STATE OF MAINE
DEPARTMENT OF HUMAN SERVICES
AUGUSTA, MAINE 04333

January 17, 1979

Subject: On-site soil investigation Guy Allen property, Lots 4 and 5,
Mud Mill Road, Augusta, Maine

SITE INVESTIGATION Show Location Of Pits on Site Plan on Page 2

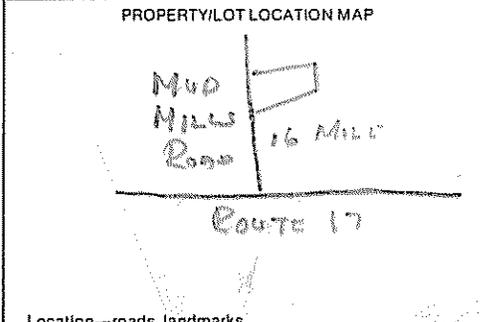
The soil profile, in the October 10, 1978 observation pit of Mr. Sparks, on lot 4 was classified by Albert Frick of this office as 3D. The soil was reported to be a sandy loam glacial till with an impervious layer in the substratum at 27 inches below the mineral soil surface. The seasonal high groundwater table, as identified by mottling, was recognized at a depth ranging from 12 to 20 inches throughout the observation pit. The test pit was located in a drainage swale, and a large portion of the bed proposed by Kenneth Sparks would be located in poorly drained soil. An acceptable site, with soil classified as 3C and mottling at a depth of 15 inches or greater, was located higher up on the knoll toward the front of the lot (nearer Mud Mill Road).
